ASM-2

Moog Ladder Filter

Size A3	FCSM No. 21/08/2010	DWG No. vcf2-filter.schdoc	Rev B
Scale	Sheet 14 of 24		Laurie Biddulph

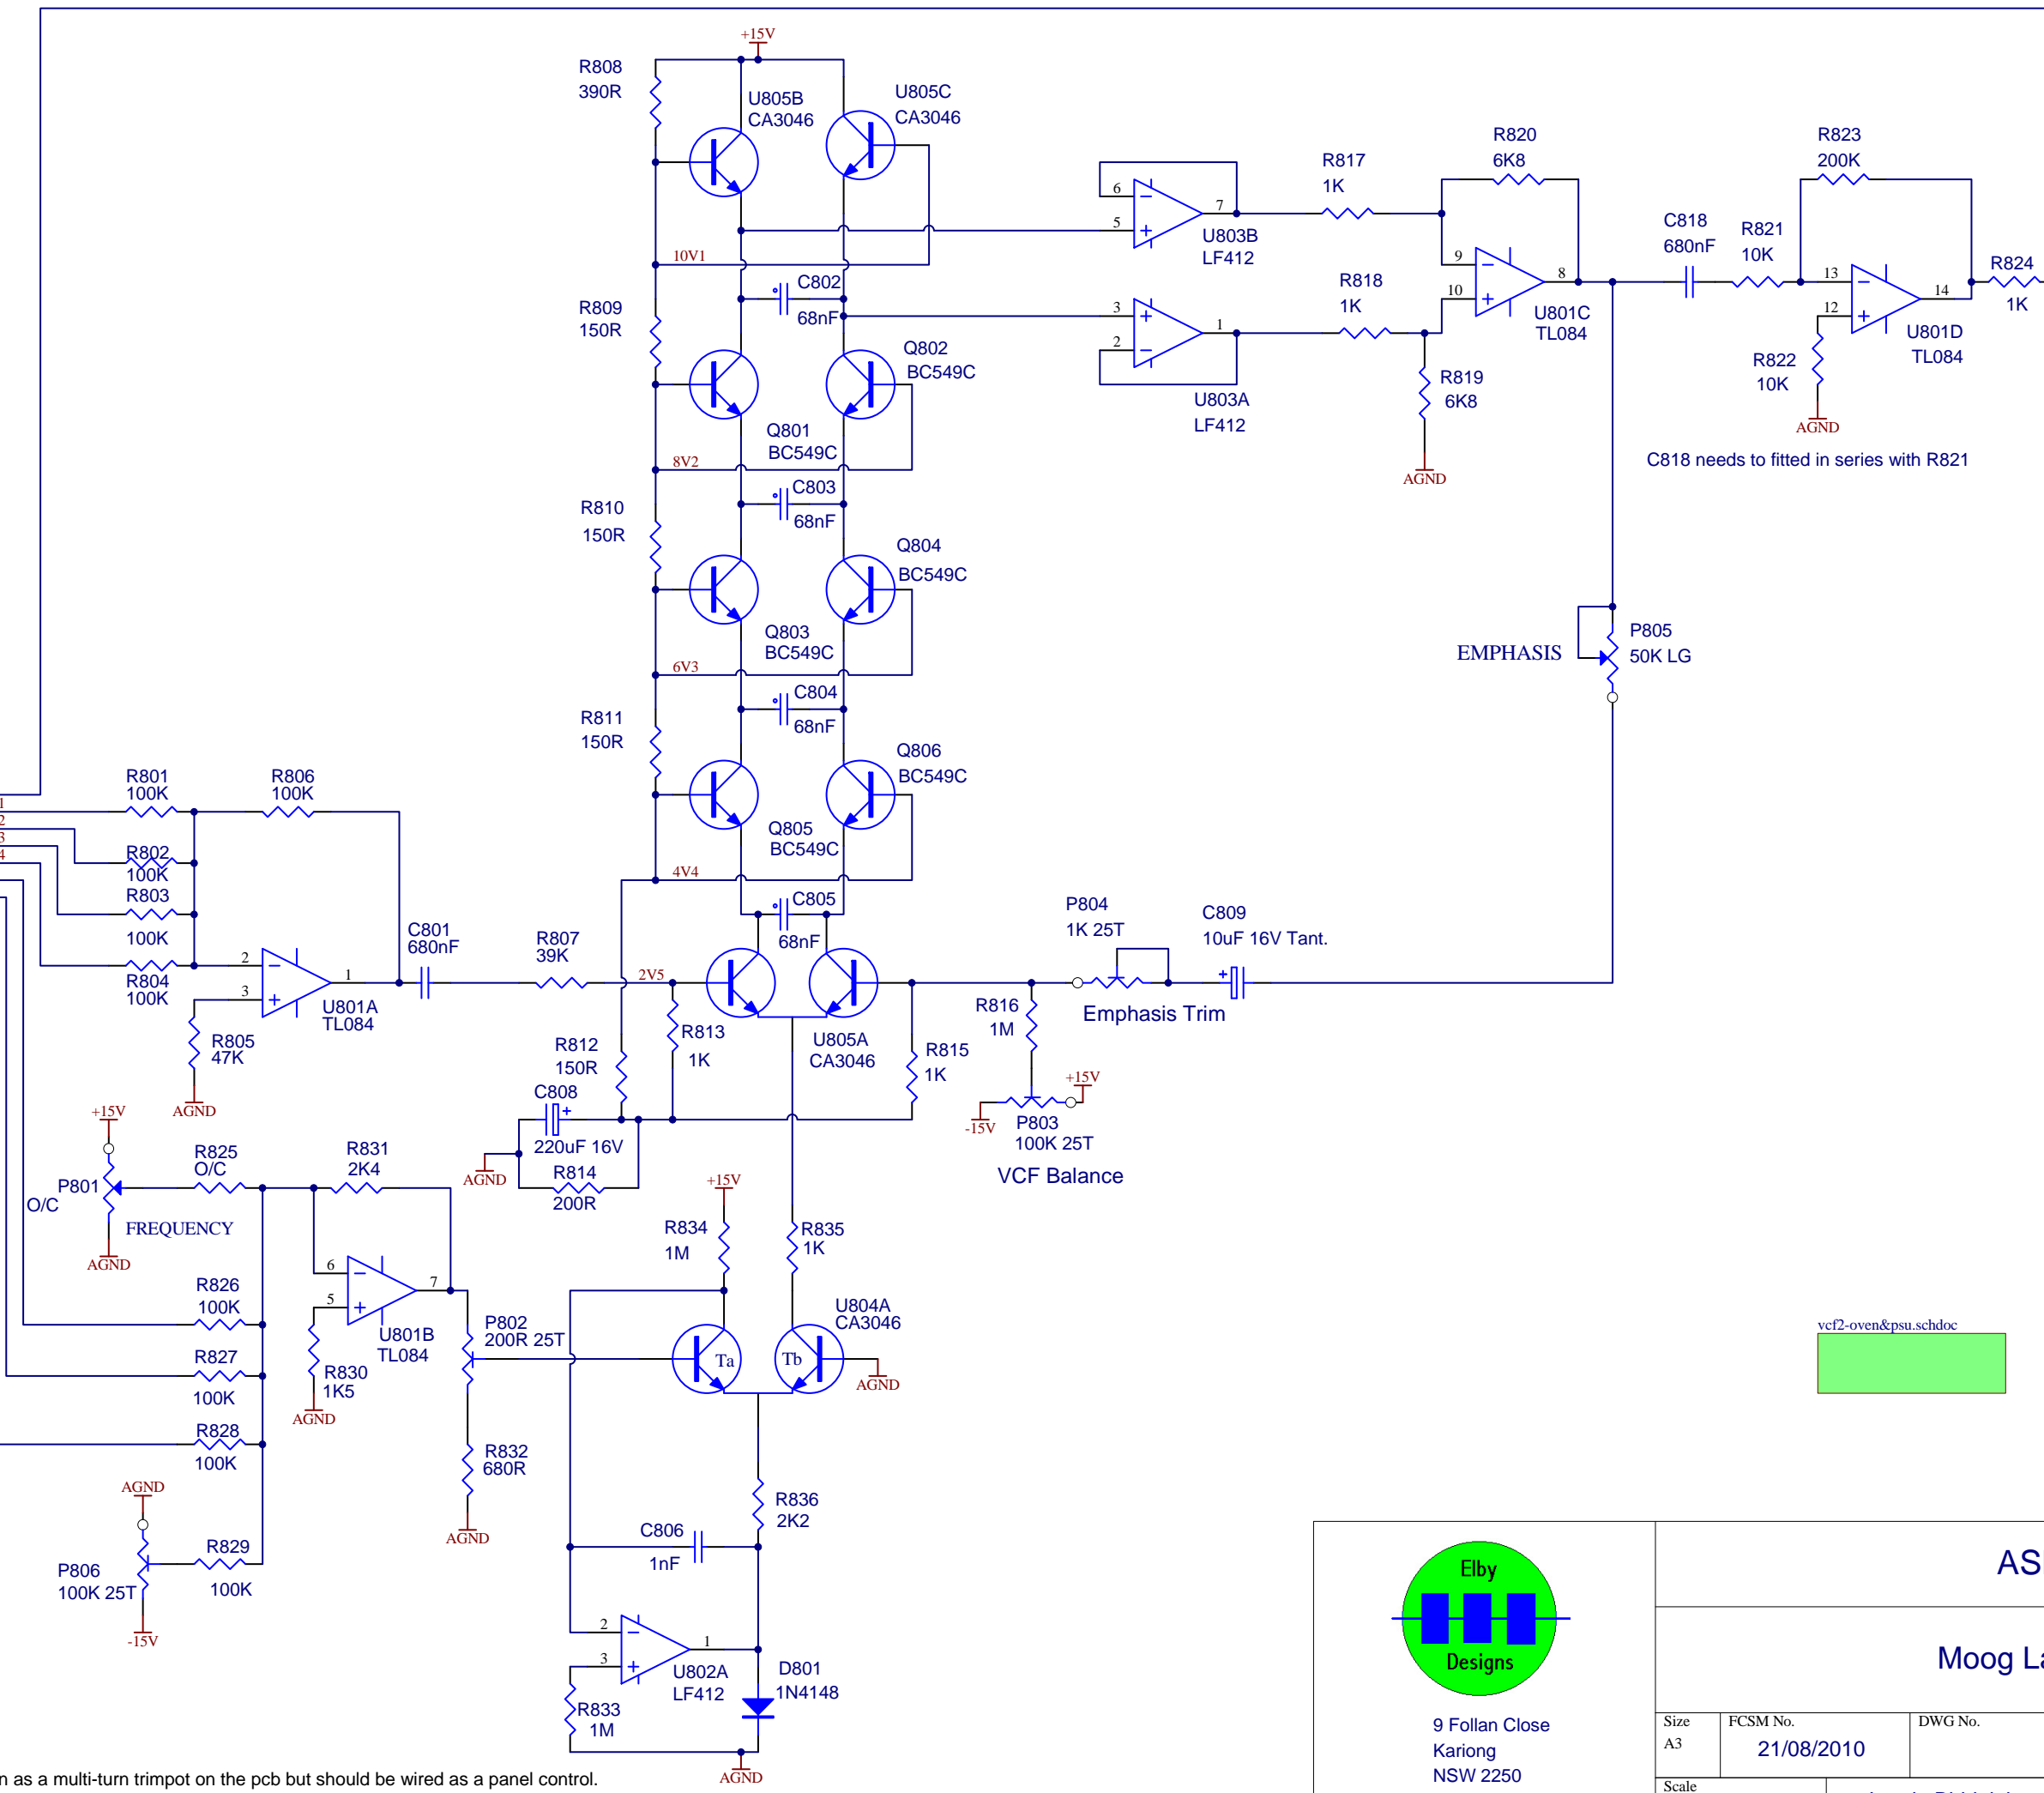
C818 needs to fitted in series with R821

P801 is incorrectly shown as a multi-turn trimpot on the pcb but should be wired as a panel control.
